# UNITED STATES PATENT AND TRADEMARK OFFICE

APPLICATION NO.	FILING DATE	FIRST NAMED INVENTOR	ATTORNEY DOCKET NO.	CONFIRMATION NO.
10/579,318	05/16/2006	Tatsuro Iwasaki	2950-061389	1885
28289 7590 07/15/2010 THE WEBB LAW FIRM, P.C. 700 KOPPERS BUILDING 436 SEVENTH AVENUE PITTSBURGH, PA 15219				
EXAMINER SINGH, SUNIL				
ART UNIT 3672		PAPER NUMBER		
MAIL DATE 07/15/2010		DELIVERY MODE PAPER

### Office Action Summary

**DETAILED ACTION**

**Fig.1**

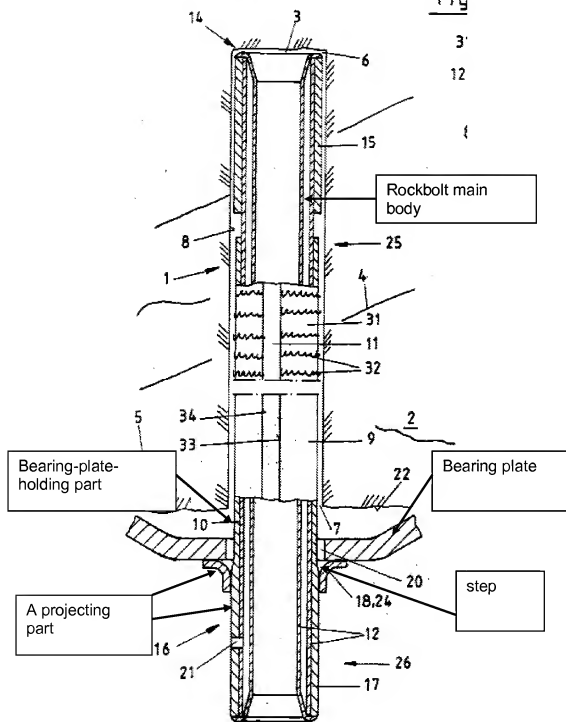
German document discloses a steel pipe rockbolt (see Fig. 1), comprising a rockbolt main body (12, see marked up Fig. below) and a pressurized-fluid-introducing sleeve (10,17, see marked up Fig. 1 below) fixed to the rockbolt main body at an end for introduction of a pressurized fluid, wherein the rockbolt main body is a deformed pipe having an expansive groove (see Figs. 2-4) extending along an axial direction of the deformed pipe, and wherein the rockbolt main body is configured to hydraulically expand upon the introduction of the pressurized fluid, the pressurized-fluid-introducing sleeve comprising a projecting part (see marked up Fig. below) with an outer diameter larger than a diameter of an aperture (20) of a bearing plate (see marked up Fig. below) and a pressurized-fluid- introducing hole (21), and a bearing-plate-holding part (see marked up Fig. below) with an outer diameter smaller than the diameter of the aperture of the bearing plate, the projecting part and the bearing-plate-holding part defining a passageway, a portion of the expansive groove of the rockbolt main body being

positioned within the passageway, whereby the bearing plate is held in contact with a step between the projecting part and the bearing-plate-holding part, whereby the bearing plate locates on an edge of a rockbolt-setting hole drilled in a bedrock or ground, and the bearing-plate-holding part extends through the aperture of the bearing plate into the rockbolt-setting hole. German document discloses the invention substantially as claimed. However, German document is silent about the sleeve being fixed by welding to the rockbolt main body. Further, German document is silent about the projecting part and the bearing-plate-holding part being a single, one-piece unitary construction, the projecting part being fixed relative to the bearing-plate-holding part. Skogberg et al. '899, '317 both disclose a sleeve fixed by welding (see col. 3 lines 3-4, col. 3 lines 5-6) to a rockbolt main body. It would have been considered obvious to one of ordinary skill in the art to modify German document by fixing the sleeve to the rockbolt via welding as taught by either Skogberg et al. '899 or '317 since such a modification would prevent the unwanted longitudinal movement between the parts. Further, it would have been considered obvious to one of ordinary skill in the art to modify German document so as to have the projecting part and the bearing-plate-holding part be a single, one-piece unitary construction, the projecting part being fixed relative to the bearing-plate-holding part since it has been held that forming in one piece an article which has formerly been formed in two pieces and put together involves only routine skill in the art. *Howard v. Detroit Stove Works*, 150 U.S. 164 (1893). With regards to claim 2, it would have been considered obvious to modify German

document to have a circumferential groove on the projecting part since such a modification allows for gripping of the sleeve during assembly.
